**Lee Nuclear Station Units 1 and 2
Description, Scope of Changes, and FSAR Impacts due to Plant Relocation and
Additional Design Enhancements**

**Description and Rationale for Lee Nuclear Station Units 1 and 2 Relocation and
Additional Design Enhancements**

Figure 1.1-202

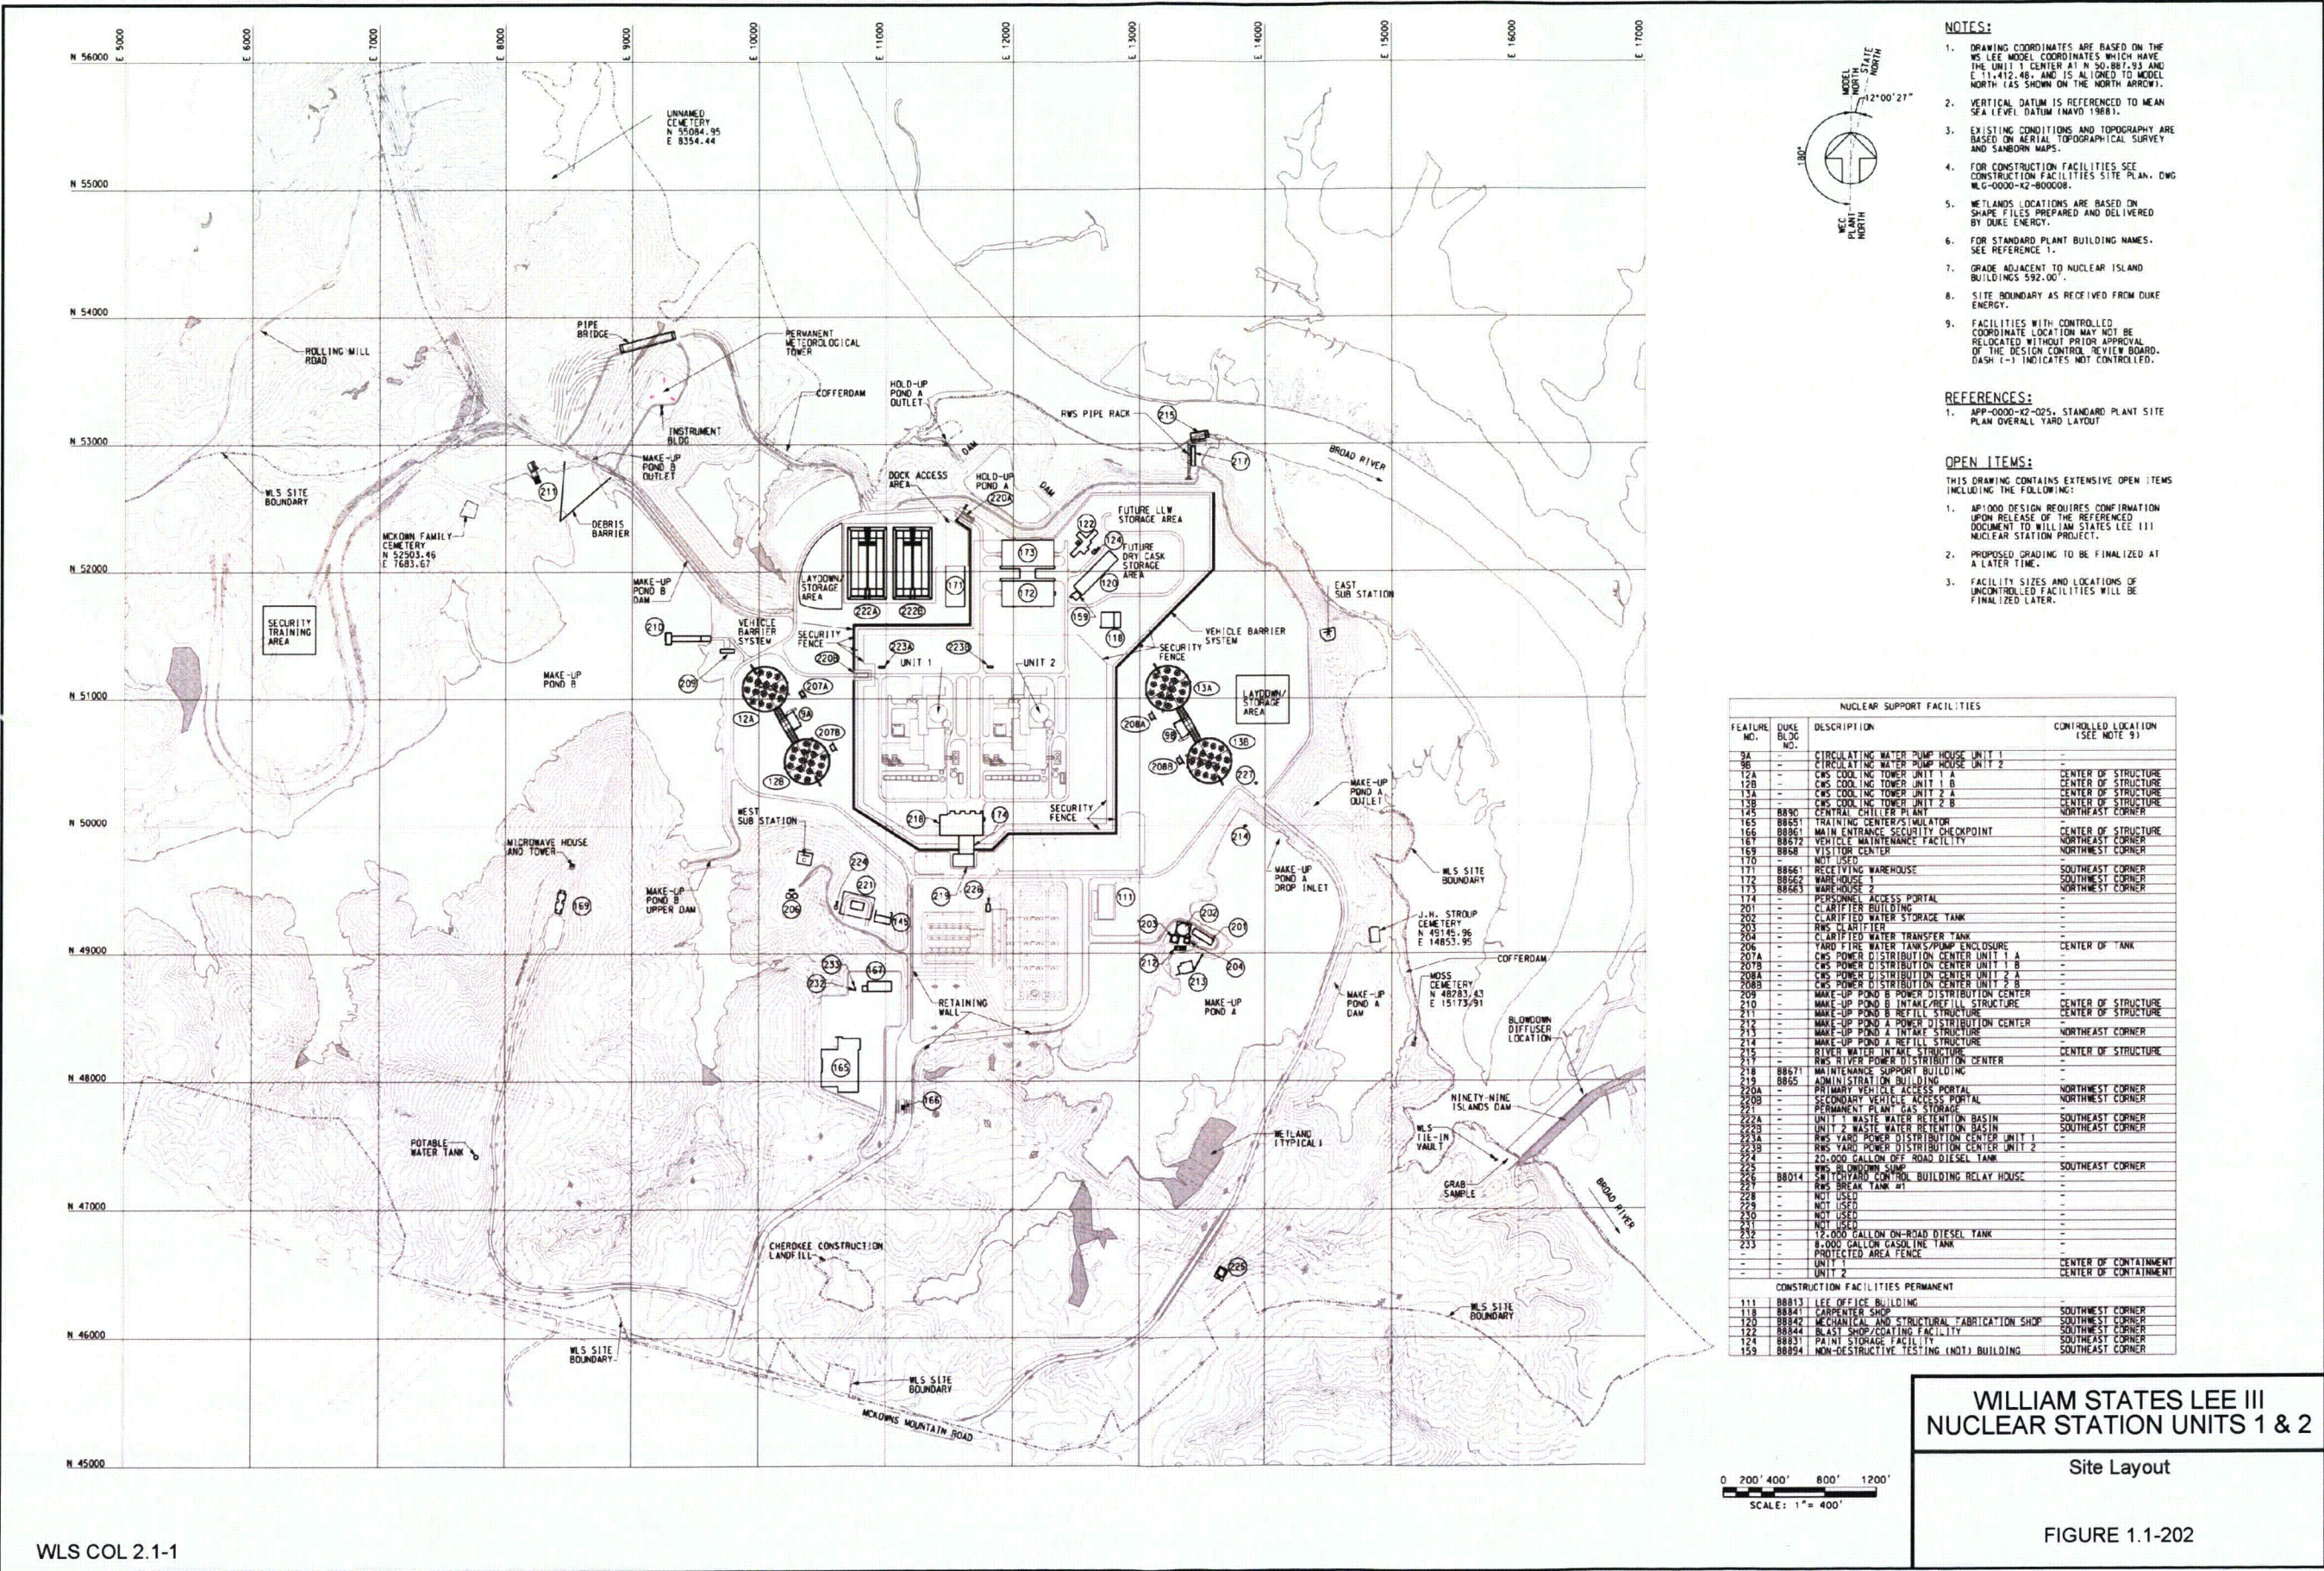
Design enhancements to the Lee Site result in changes to a figure in the FSAR. These changes are related to the addition of the debris barrier and the extension of the rail spur to the site layout.

2. COLA Part 2, FSAR Chapter 1, Figure 1.1-202 is revised as follows:

Figure 2.1-209

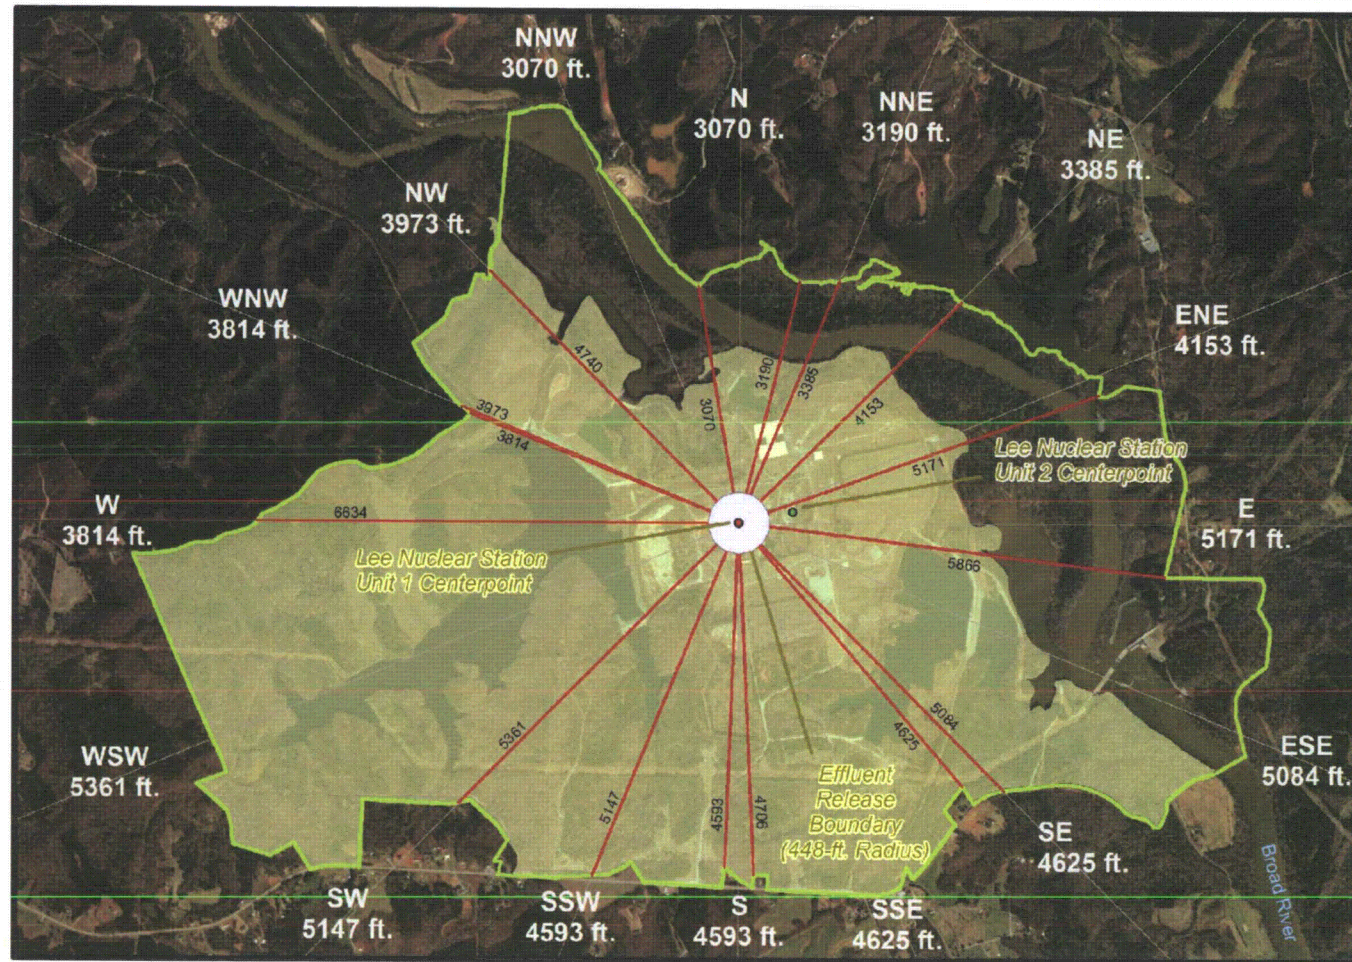
5. COLA Part 2, FSAR Chapter 2, Figure 2.1-209 is deleted to provide EAB distances for each unit, presented as Figure 2.1-209A and Figure 2.1-209B as follows:

FIGURE 2.1-209A

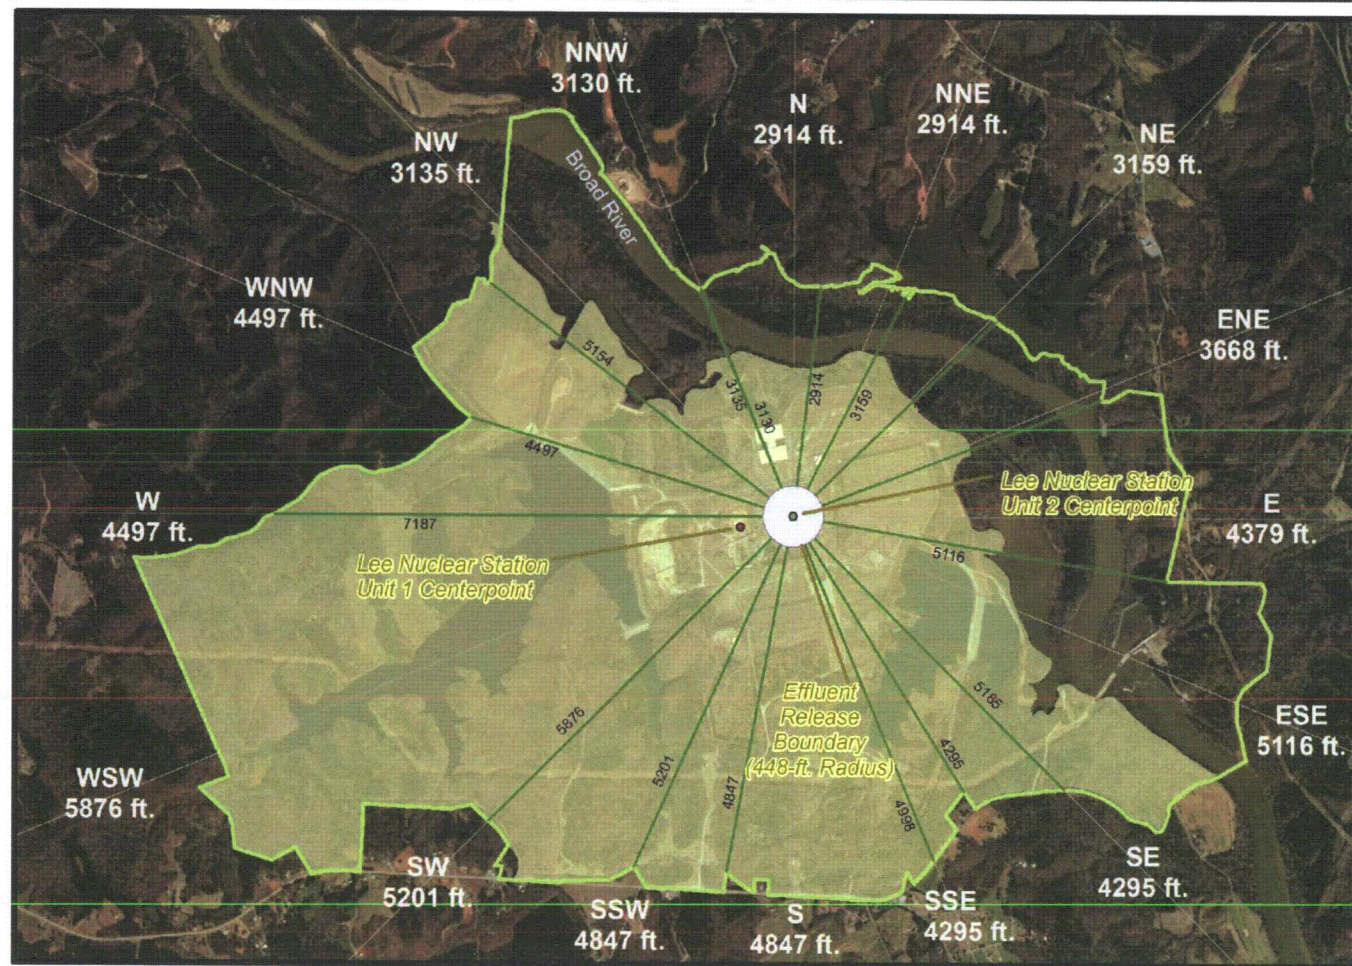
The Exclusion Area Boundary for the Lee site has been modified. The EAB has expanded to allow the site to satisfy the AP1000 DCD 0.5 mile minimum distance parameter to the EAB (DCD Table 2.1, Sheet 3 of 4) from each reactor center point. The revised EAB boundary was extended across the Broad River to the northern direction and slightly modified portions of the southern and western boundaries, as illustrated in Figures 2.1-209A and 2.1-209B.

6. COLA Part 2, FSAR Chapter 2, Figure 2.1-209A is added as follows:

FIGURE 2.4.1-201

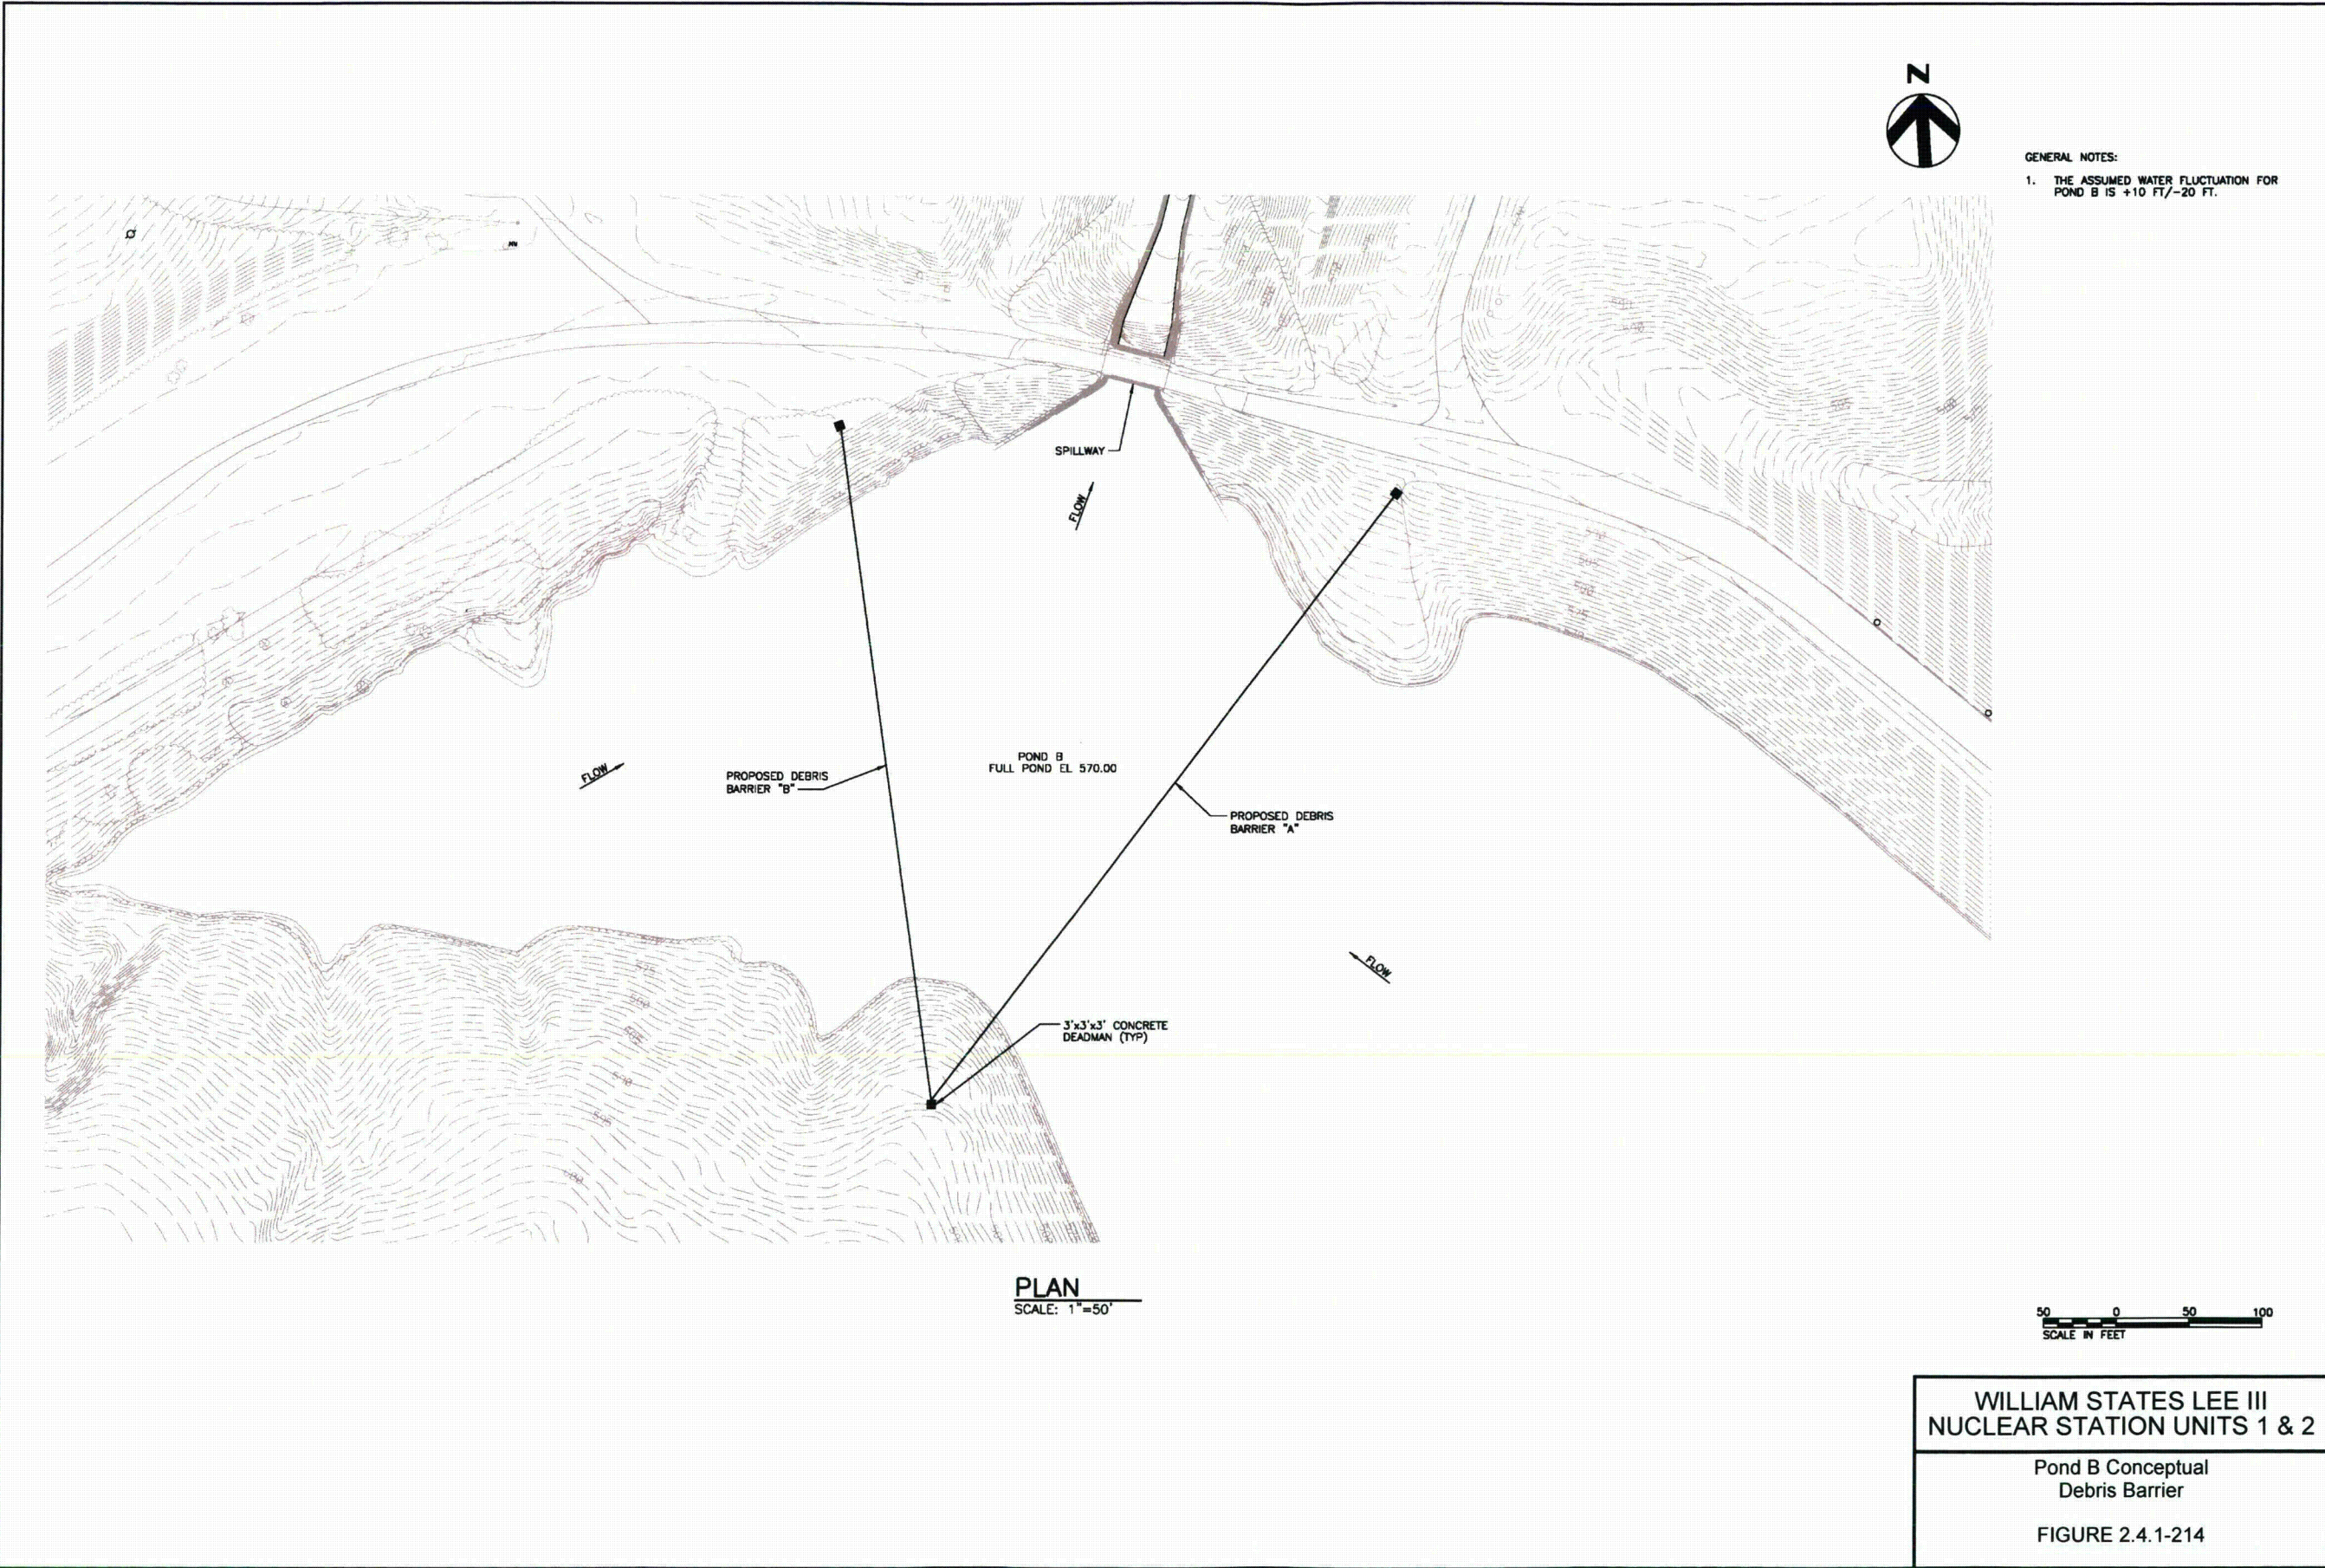
42. COLA Part 2, FSAR Chapter 2, Figure 2.4.1-201 is revised as follows:
